SUBJECT: **James A. FitzPatrick Nuclear Power Plant**
Docket No. 50-333
Response to Request for Additional Information Regarding
Certain Diagnostic Team Findings at
the James A. FitzPatrick Nuclear Power Plant

**REQUEST FOR ADDITIONAL INFORMATION
RESOLUTION OF SPECIFIC DET FINDINGS**

FIGURE 1

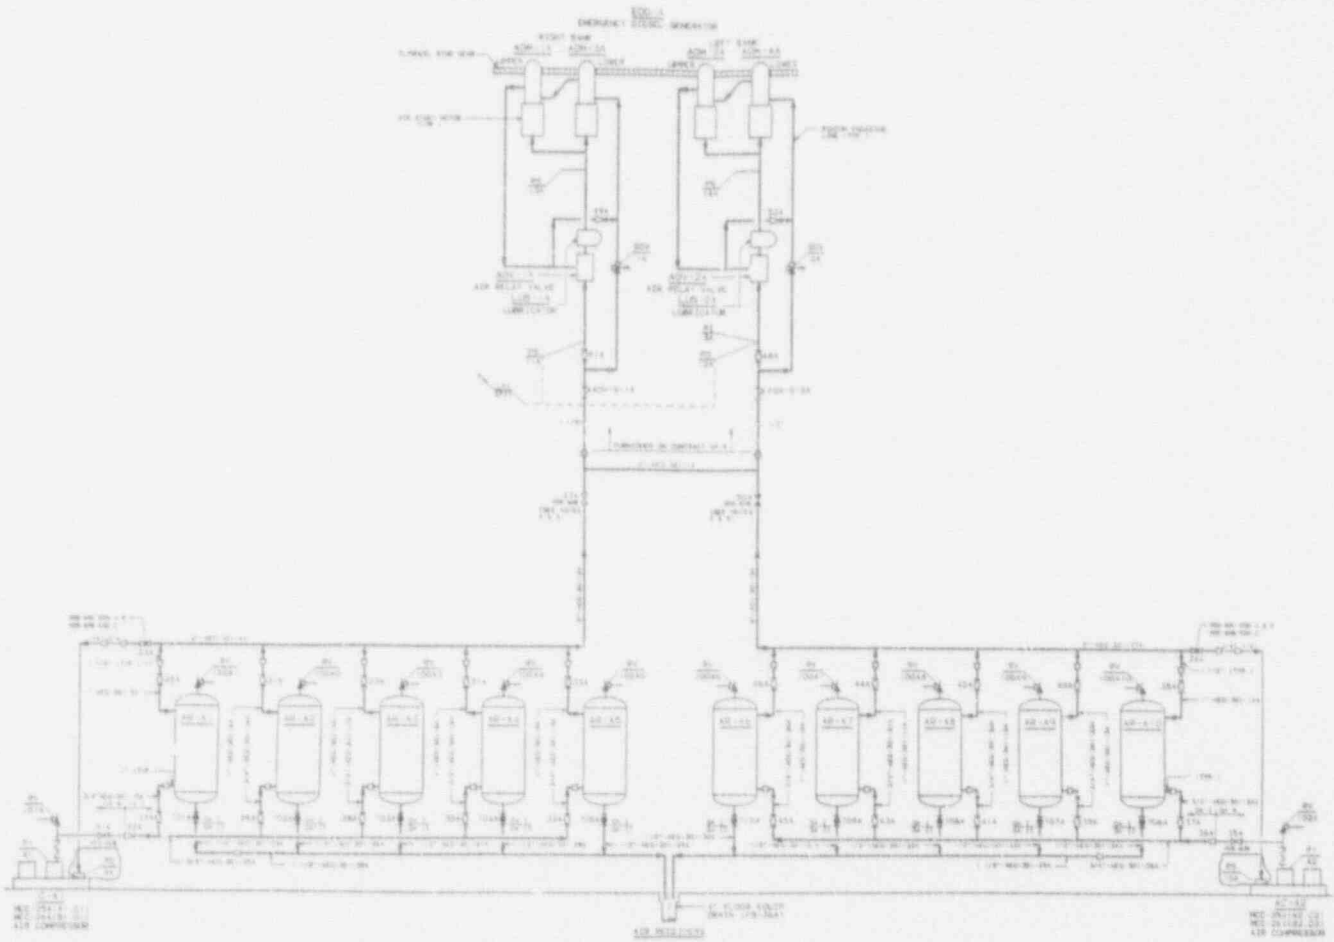
- B. Several design deficiencies were noted by the team involving the Emergency Diesel Generator (EDG) air start system. For example, a common header between air banks made the system not entirely independent or redundant as required by the Final Safety Analysis Report (FSAR). The team also noted several design modifications initiated as early as 1988 to correct many of these deficiencies that had not yet been implemented because of improper priority assignments.

1. Can each air start motor set be tested individually?

3. There appears to be a discrepancy between an EDG's air start system piping configuration and FSAR Section 8.6.3 statement on independence.

4. Does the EDG's licensing basis require independency between redundant air start sets supporting each diesel?

5. Why is one air start receiver bank normally isolated and does this configuration reduce air start capacity to less than 10 EDG starts?

6. When one of the two air start compressors is out of service is its associated EDG declared inoperable?

Plant safety loads are separated into two independent and redundant load groups. Each load group (emergency bus) is supplied by two emergency diesel generator units. Each diesel generator has an independent fuel oil and starting air system. The starting air system (see figure 1) consists of two 100% capacity air start motor sets. A motor set has 1 starting solenoid, 2 air start motors, 1 air relay valve, and 1 lubricator. Ten air receivers are divided into two banks, each having a dedicated air compressor. A common header between receiver banks permits starting air from either bank to supply all 4 starting motors.

No, the air piping configuration does not permit testing an individual air start motor set. The monthly EDG test is conducted with the air start motors and air receiver banks in the normal operating lineup verifying an EDG's ability to start in its standby configuration. Instead of individually testing a motor set, the air start motors are inspected during the test for proper operation. The inspection includes a visual check of the air start motor pinion gear teeth for damage or obstruction, air flow exhausting from the motor, and proper lubrication of the air motor (Reference 2).

The EDG test procedure (Reference 2) will be revised to require alternating air start receiver banks each month.

The Authority agrees that an air start motor system's two redundant trains are not independent. However, the Authority considers the EDG air starting system acceptable. The Authority also had concerns regarding these FSAR statements and addressed these concerns in Safety Evaluation JAF-SE-89-034 (Reference 3).

This safety evaluation concludes that each EDG (including its respective air start system) is independent of the other EDGs. Each EDG's air start system has redundant active components (two 100% air start motor sets) for high reliability but its air start system was not designed to meet single failure criteria. Single failure protection is provided by independent emergency buses and redundant EDGs having their own air start system. The Authority acknowledges the FSAR EDG air start system description is ambiguous and will submit a change as part of the July 1992 update.

The current configuration increases the reliability of an EDG by maintaining a reserve capacity of starting air and does not reduce the FSAR stated capacity of 10 EDG starts. Testing has verified that one bank provides enough air for five or more successful starts (Reference 3). Isolating one bank of receivers maintains a reserve capacity for five additional starts with operator action. If an EDG failed to start using the air available in five receivers, troubleshooting and corrective action could be performed prior to valving in the isolated bank. Operating with one receiver bank isolated enhances overall EDG reliability and protects against a single passive failure in the air system.

No. When one compressor is out of service, its associated air starting system and EDG remain operable. EDG operability is dependent on the receivers holding air at 180 psig. The loss of a compressor does not effect the stored air in the receivers.

Normal lineup for an EDG's air start motor system is to have one bank of air receivers isolated (in reserve) and the other air receiver bank active supplying pressurized air up to the air start solenoids. The isolated bank will remain pressurized. Its air compressor cycles on and off to maintain pressure greater than 180 psig. The compressor's pressure switch is functionally checked monthly during the EDG surveillance. The active bank is also pressurized by its air compressor and a low pressure condition will be alarmed in the Control Room by redundant pressure switches PS-11 & 12. This lineup provides air for 5 successful starts using the active bank plus a 5 start reserve air supply with operator action.

If one of the two compressors is taken out of service an operator can isolate the compressor from its respective air receiver bank and open both air receiver bank isolation valves. Under this lineup all ten receivers will be pressurized by the inservice compressor. If a low system pressure condition were to occur it would alarm immediately notifying operators of the degraded condition. While this lineup reduces operating flexibility, the 10 start air capacity is maintained and the EDG remains operable.
